# LAUREL LAKE VILLAS

## HUDSON, OHIO

**AHBR DESIGN REVIEW**  
**MAY 27TH, 2026**

# STAFF COMMENTS 2026

# BRANDYWINE, VILLA 4 – REVISED ELEVATIONS

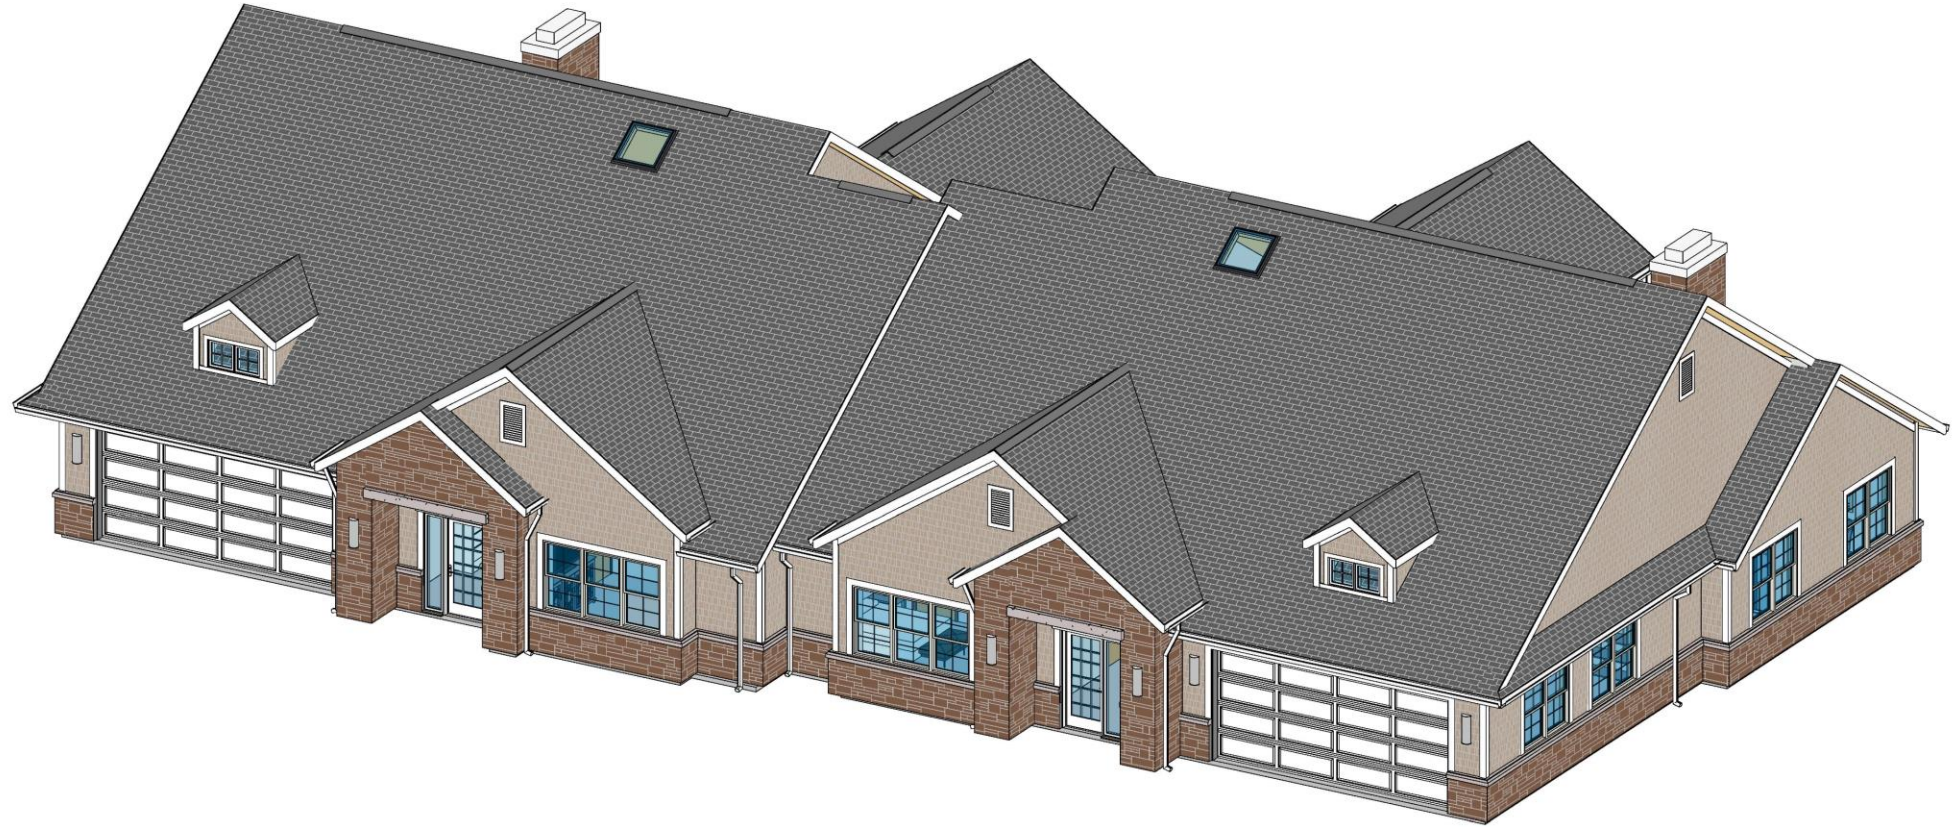
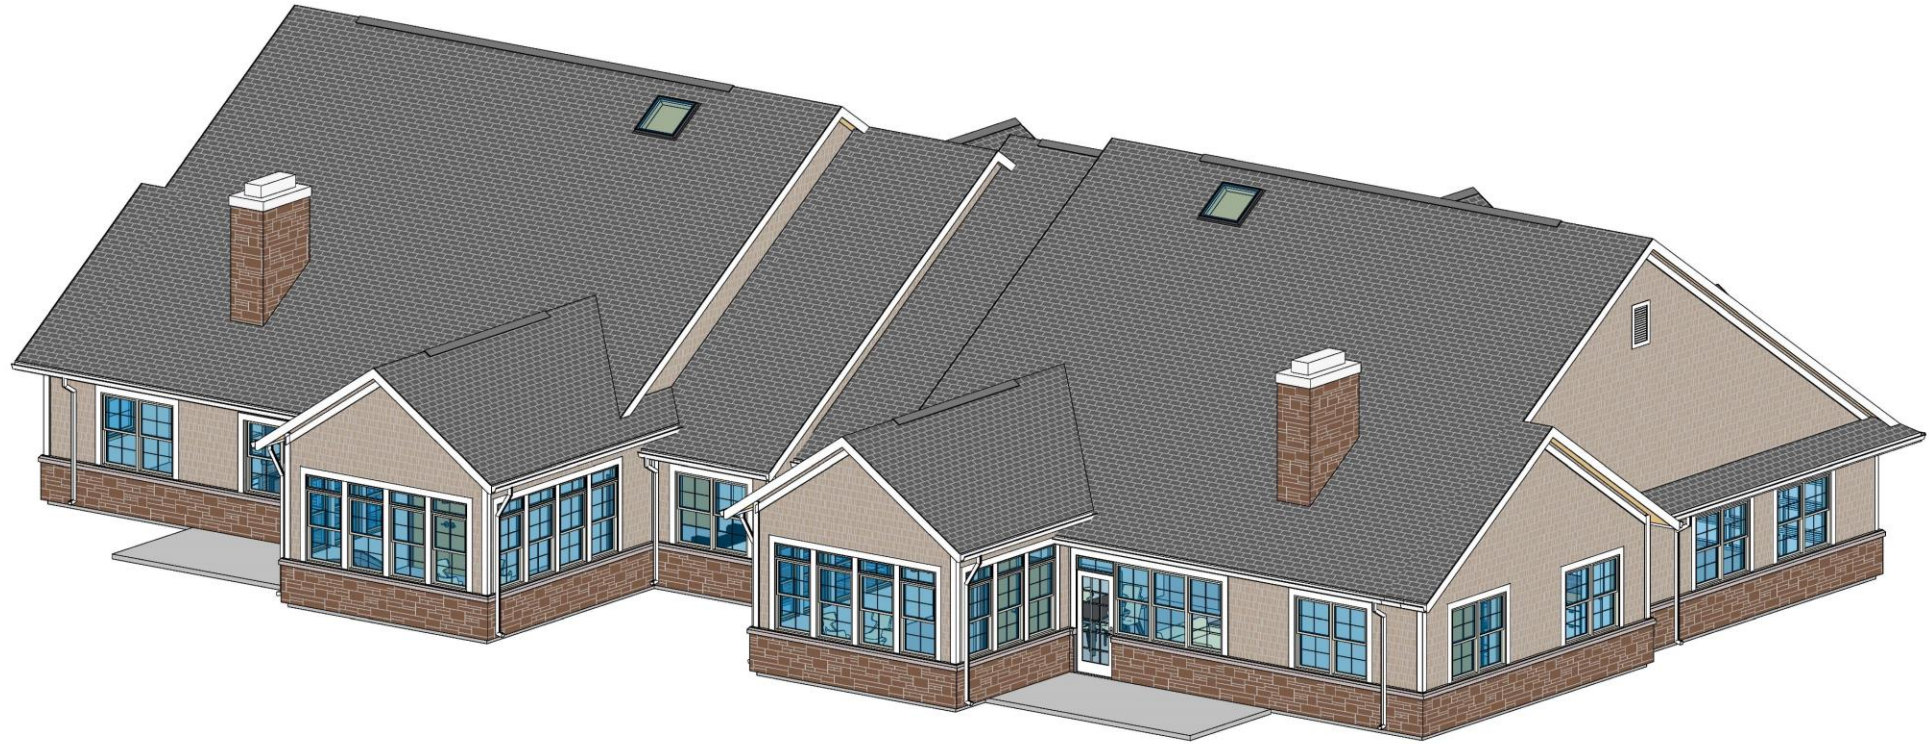
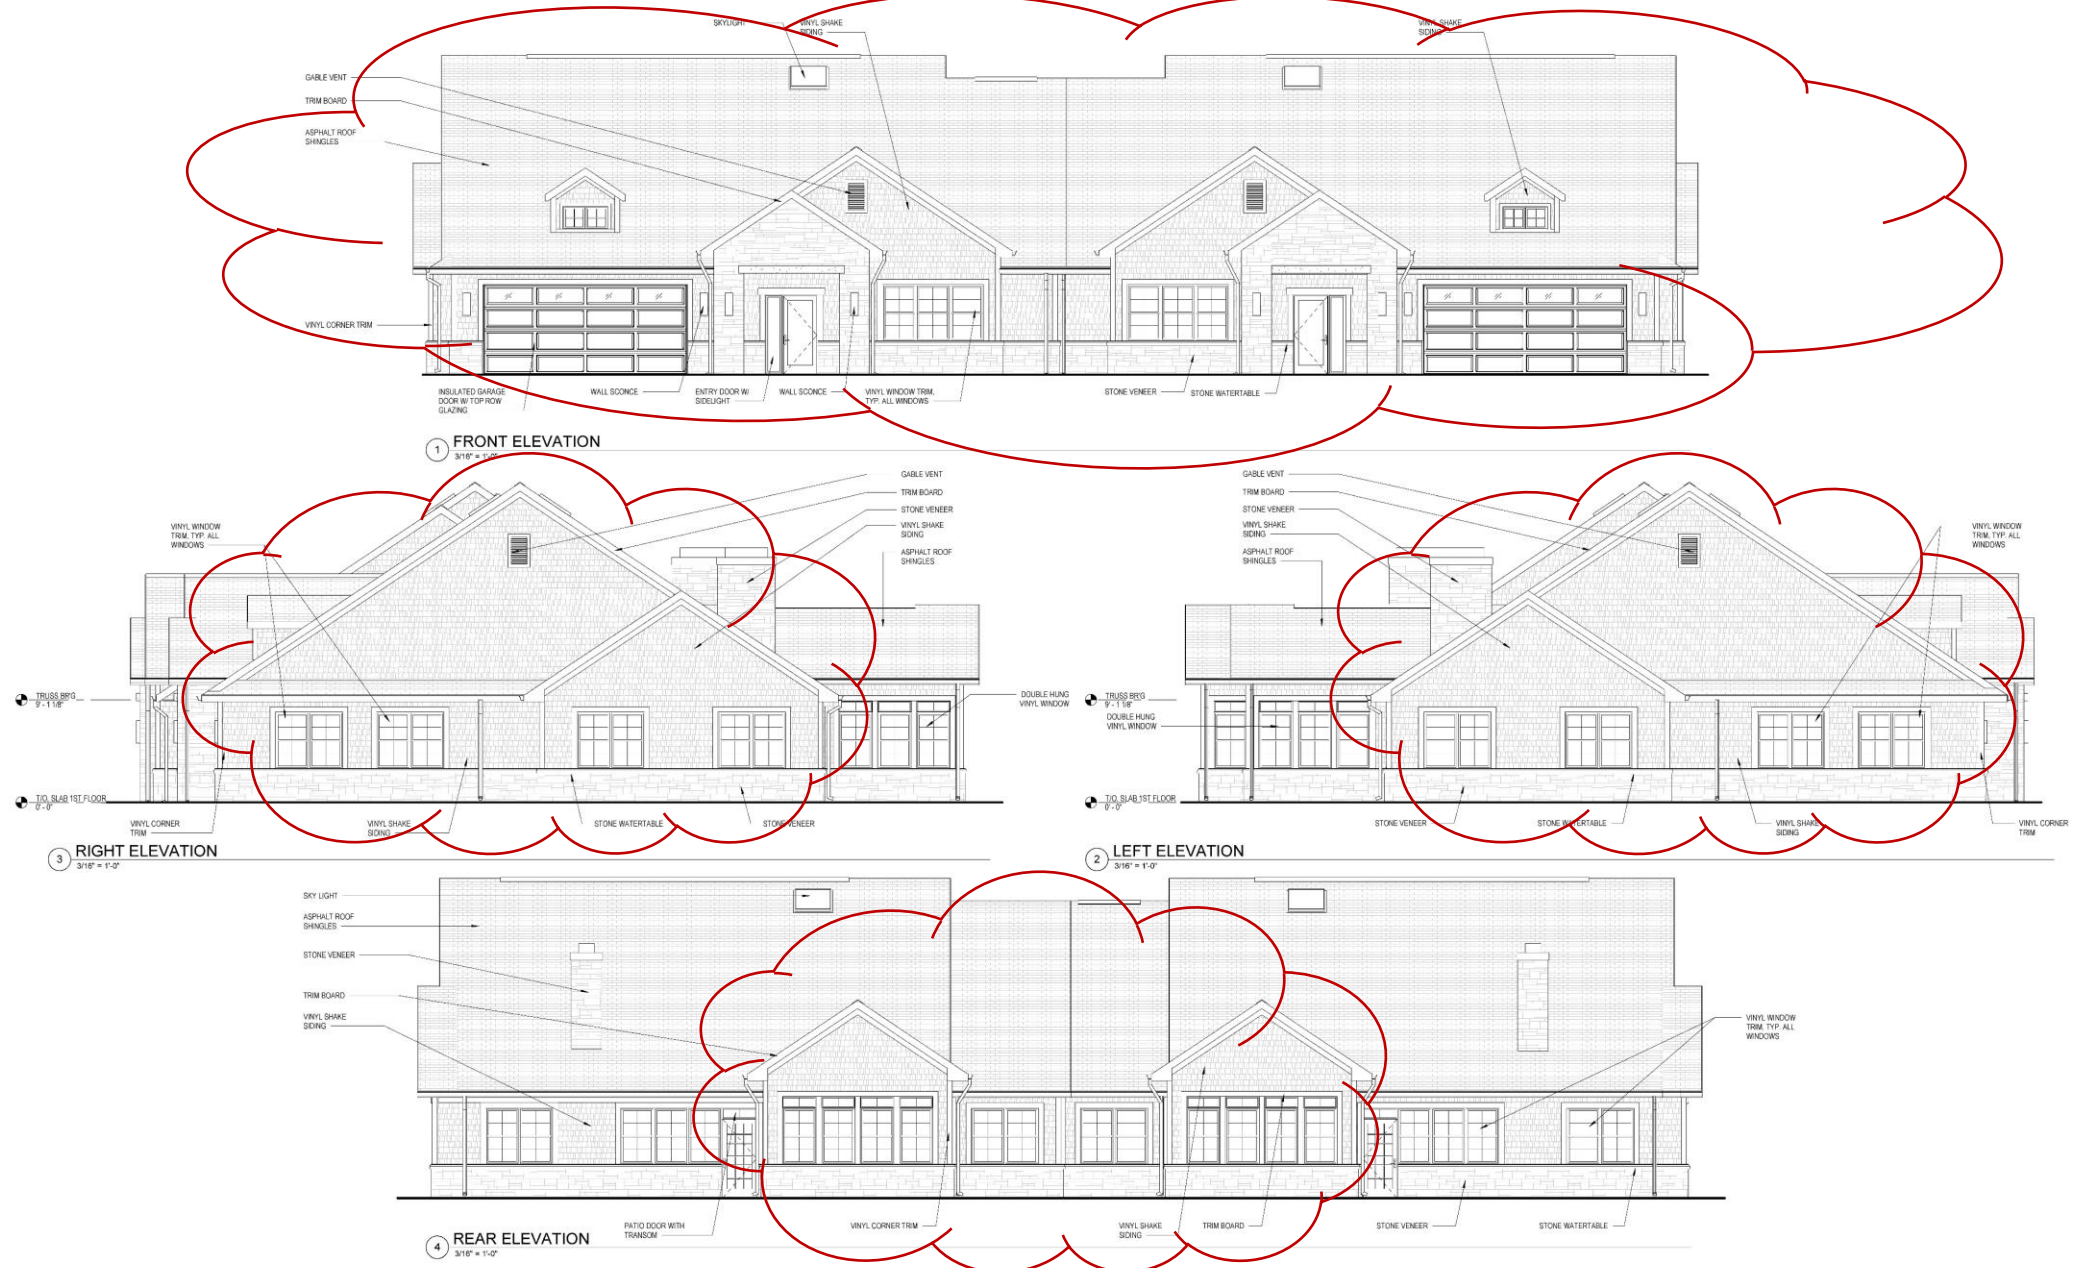
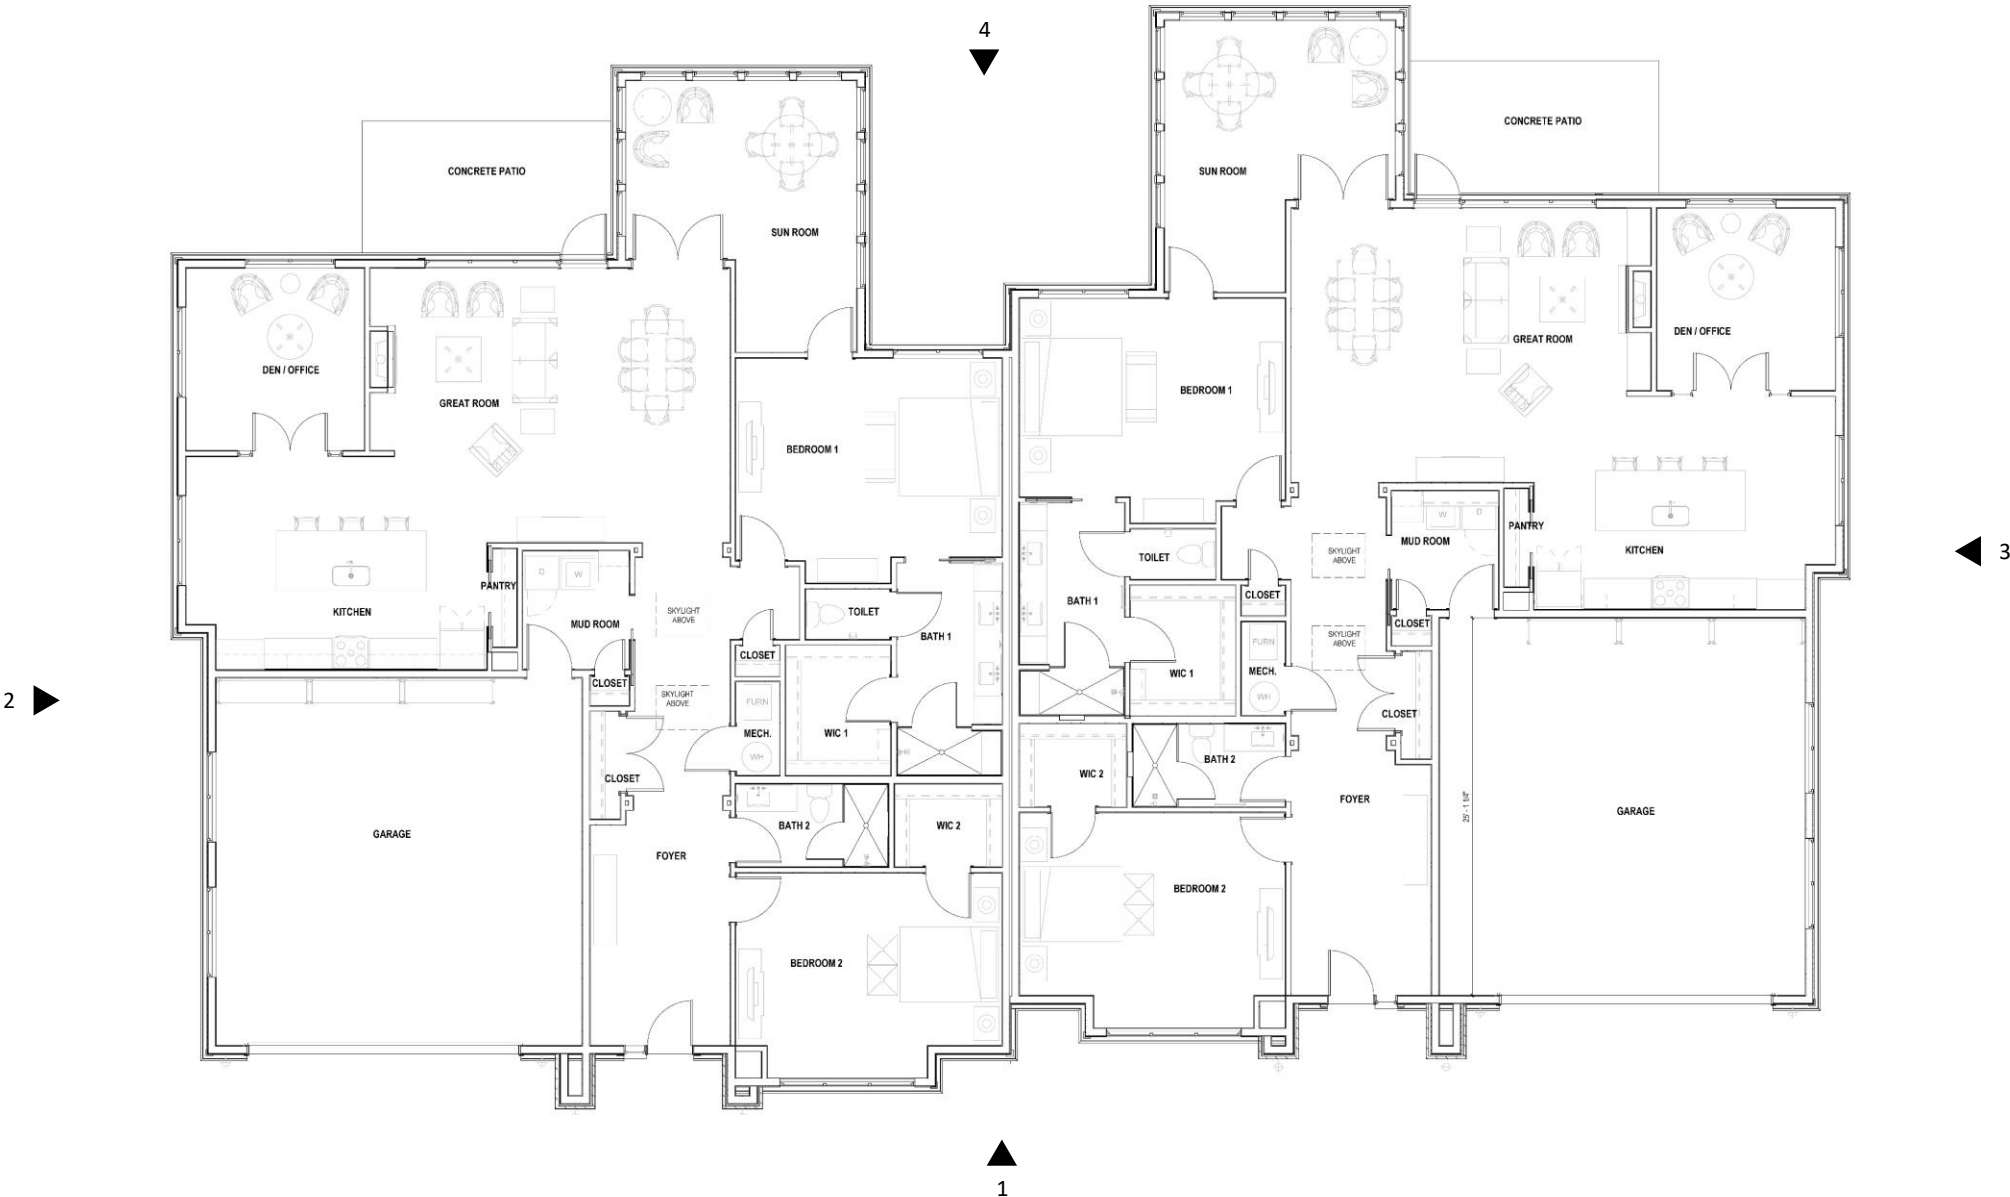
1. Section IV-3 (b)(3) – Forward facing garages.
2. Section IV-3 (b)(2) – Front Faceoff main body is 18” in front of all wings.
3. Section III-1(d)(5) – Fenestration every 12’
4. Section IV-3(c) – Roof to be same shape as main body.
5. Section III-1(g)(3) – Sunroom foundation material.
6. Window trim – Consistent on all elevations.

# VILLA 5 – DESIGN OPTIONS

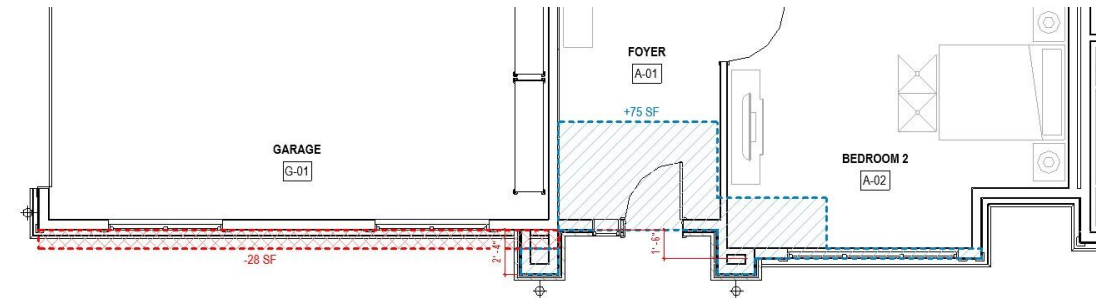
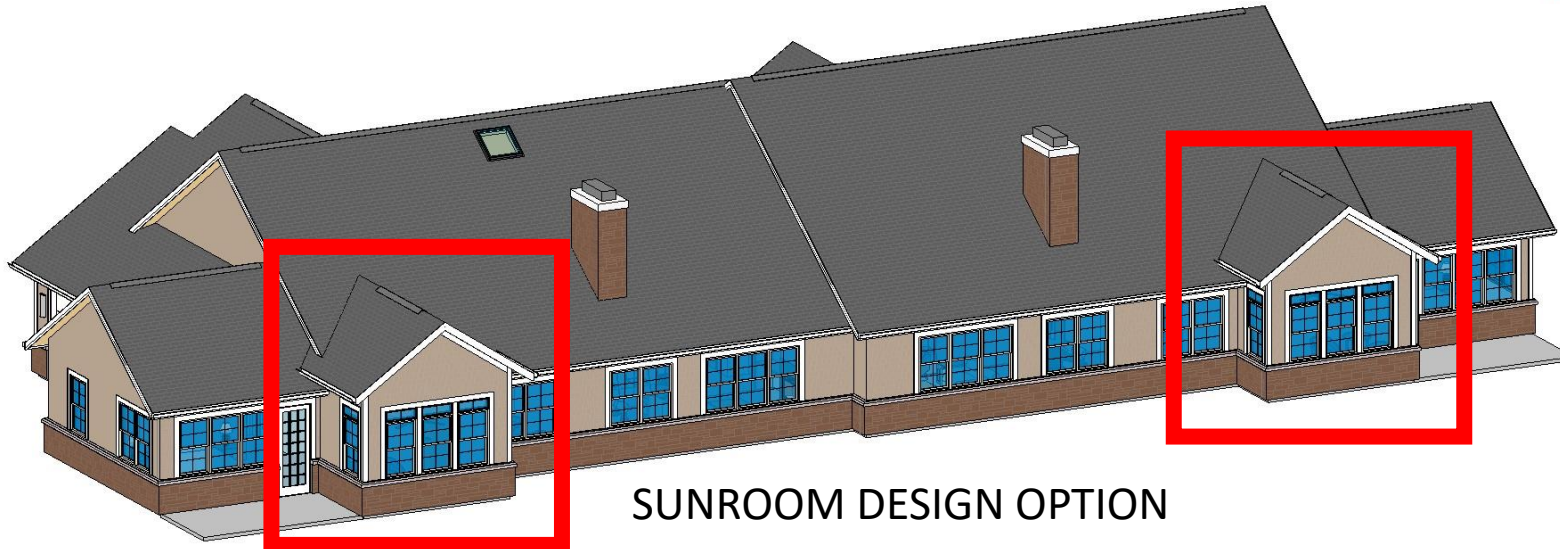
1. Section IV-3 (b)(3) – Forward facing garages.
2. Section IV-3(g)(2) – 5' projections treated as wings
3. Section III-1(g)(3) – Sunroom foundation material.
4. Section IV-3(f)(1) – Consistent detail applied throughout
5. Section IV-3(c) – Roof to be same shape as main body.
6. Section III-1(g)(3) – Sunroom foundation material.
7. Window trim – Consistent on all elevations.
